Access Compliance Report Public Rights-of-Way (Curb Ramps)

Main Street: FAIRHAVEN_AVE Cross Street: S_OAKWOOD_ST Location: NW

ADA ID: RPAT211111103038 Ramp Type: Type 4 - Parallel Initial Pass/Fail: Fail Overall Compliance: No Severity Score: 2

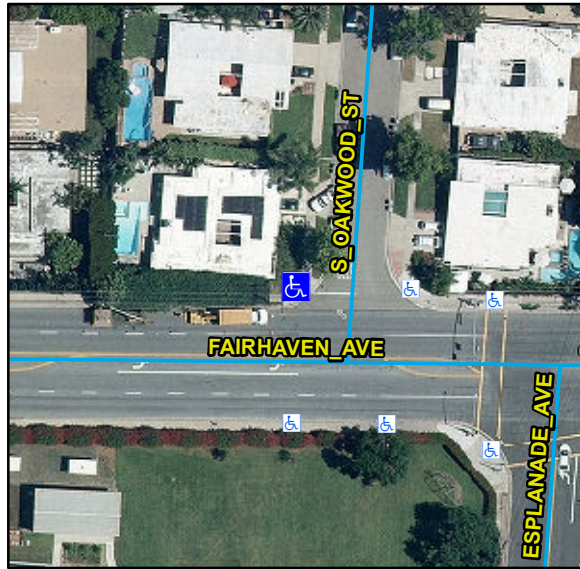
Surveyor Notes:

N/A

Possible Solutions:

Remove & Replace Curb Ramp With Two New Directional Ramps or Equivalent.

OC Std/PROW:

R304.5.3, STD 1115
